Duquesne Light

August 6, 1981

Reference: Beaver Valley Power Station, Unit No. 1
Docket No. 50-334
DCP 451

WESTINGHOUSE DRAWING NO. 1081H94

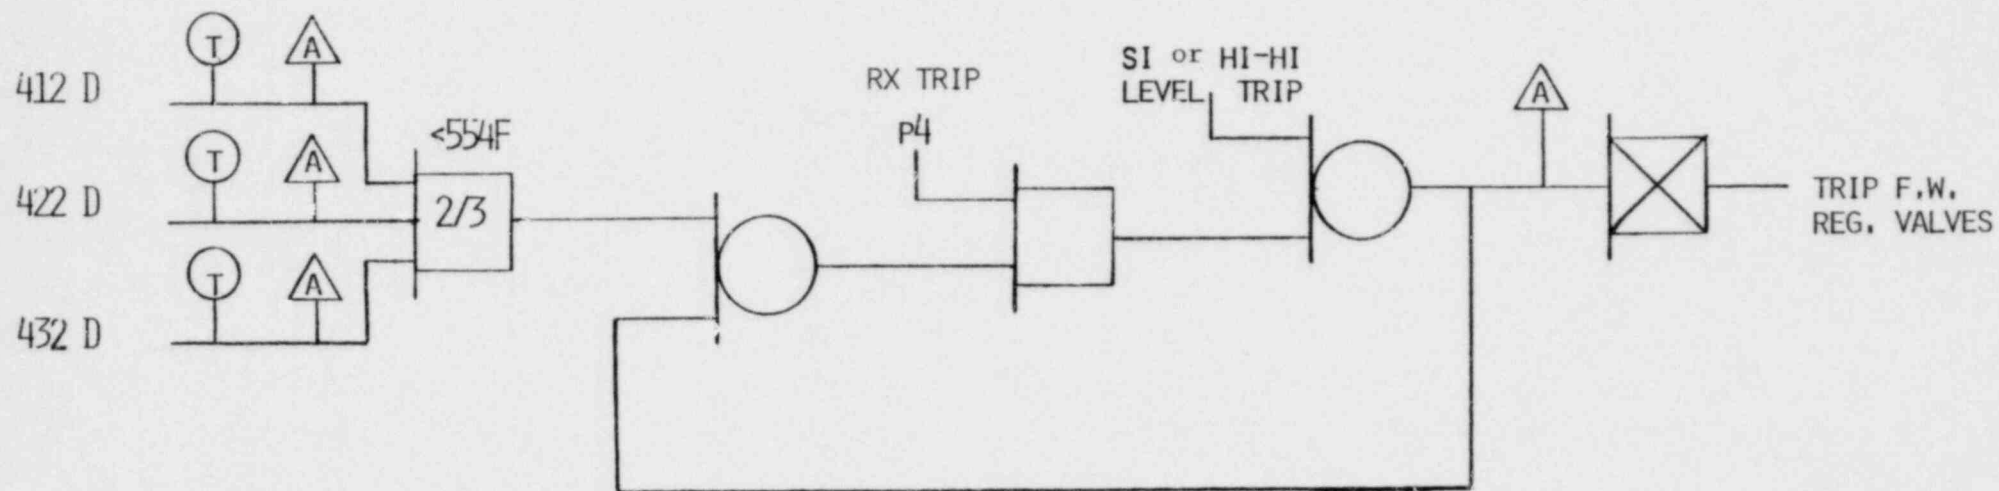
1. The Main Feedwater Valves will not automatically reposition upon reset of the SIS signal since a separate and redundant trip on the valves still exists. This signal is developed by a low Tave (less than 554F) coincident with a reactor trip signal (P4). Refer to the attached diagrams which depict this additional trip on the valves and to FSAR Figure 7.2-1 instrumentation and control system for additional information.

NOTE: The K601 relay contact is dropped out by an SIS signal and the K620 relay contact is operated by either a high-high steam generator level or the P4 and 554F logic.
